The Phaeton Project

Hardware Purchase Document

16.82

October 20, 2003

Figure 3: System Architecture

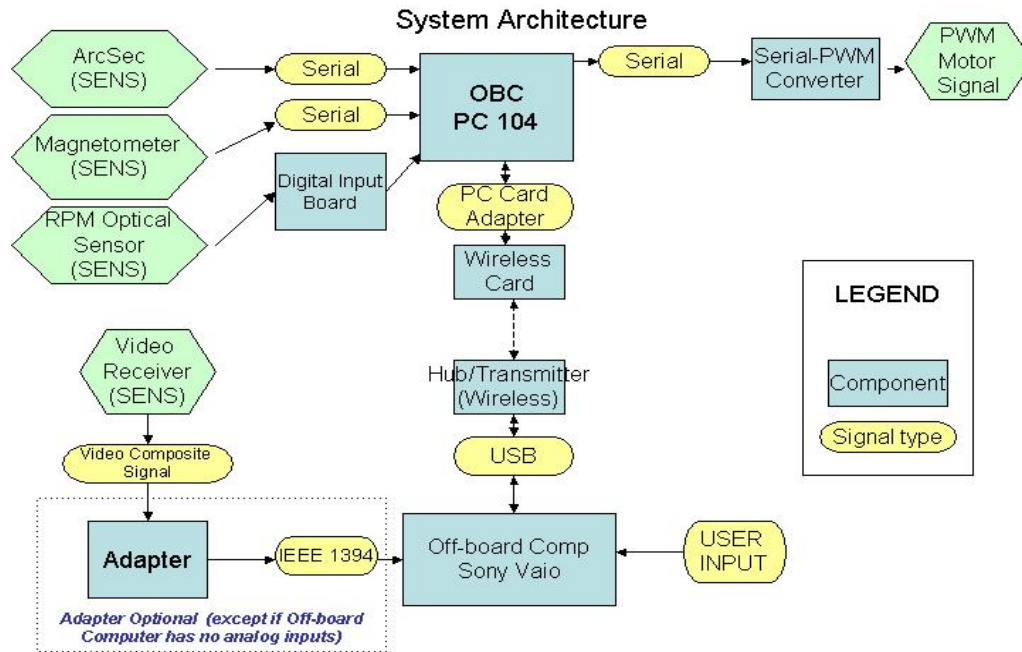
Figure 3 is an excellent graphic. It would have been useful at the beginning of the document, too. Nice use of shape and color to indicate categories. Good work.

Figure 4: C_T vs. V/V_{ref}

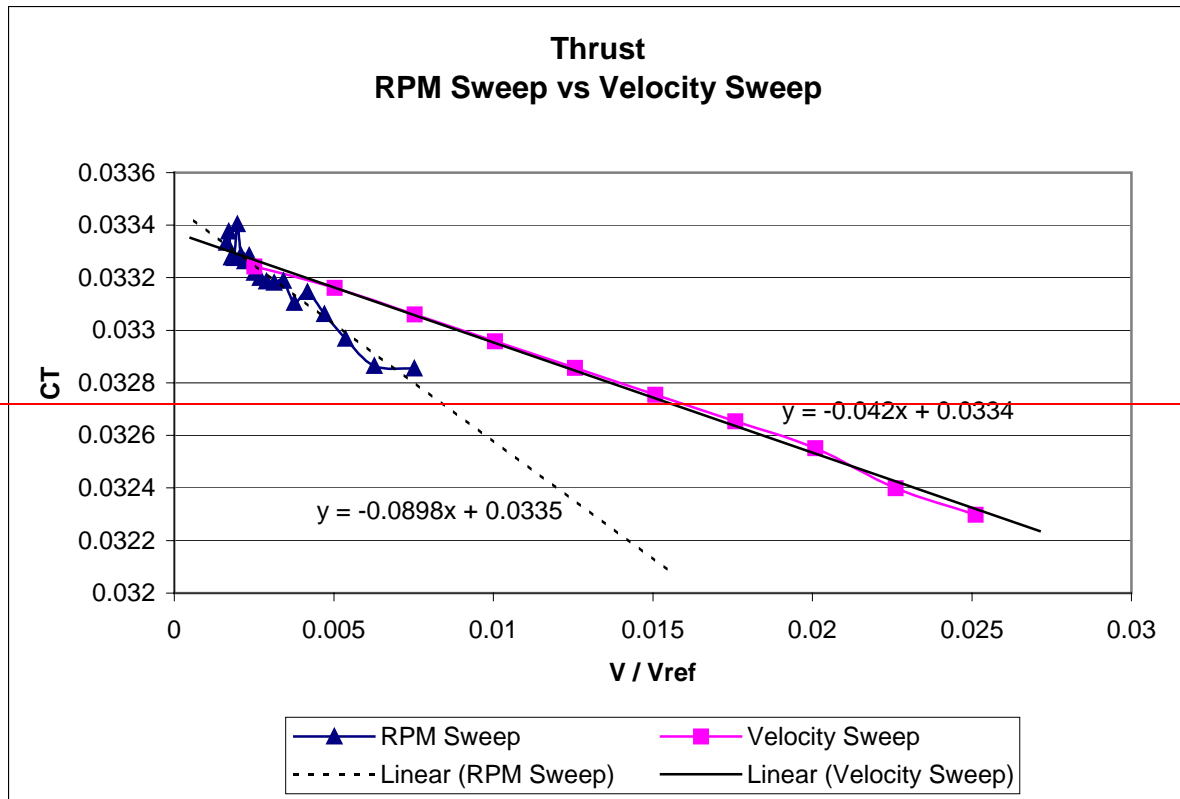
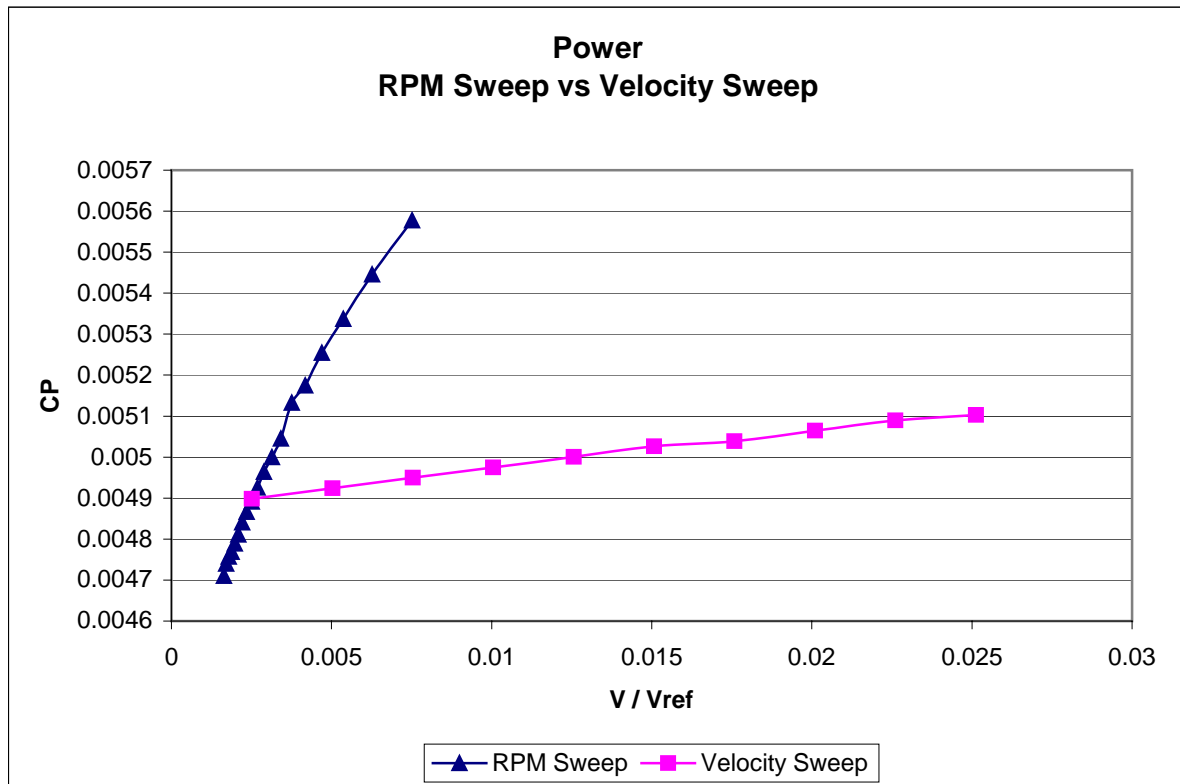
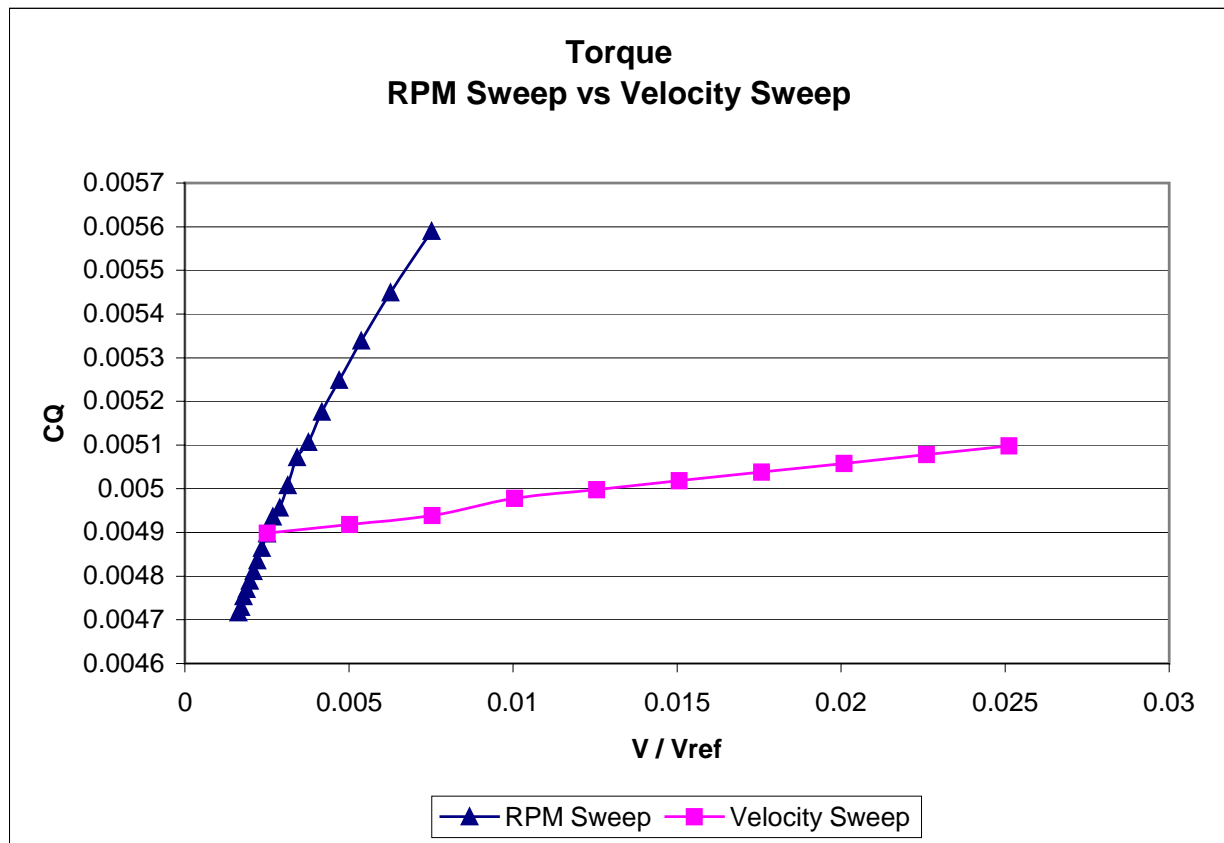
These graphics are useful, and I think they might serve better in the body of the document.
